Manual Supplement

Manual Title: 1750 Operators Print Date: October 2006 Revision/Date: Supplement Issue:2Issue Date:2/07Page Count:2

CD Title: CD PN: 1750 2774701 punt: 2

Figure 12. 2-Element Data

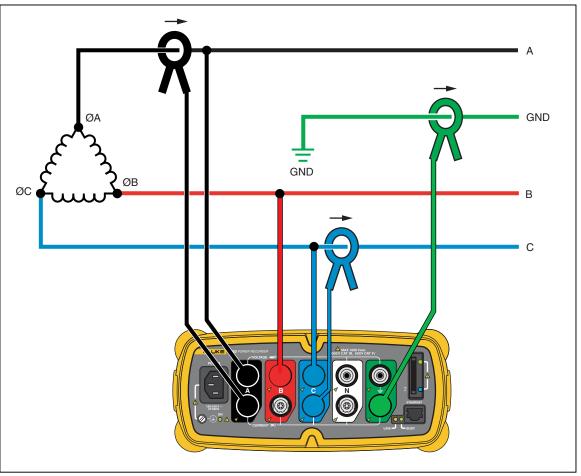
Change #1

On page 23, replace Figure 12 with the following:
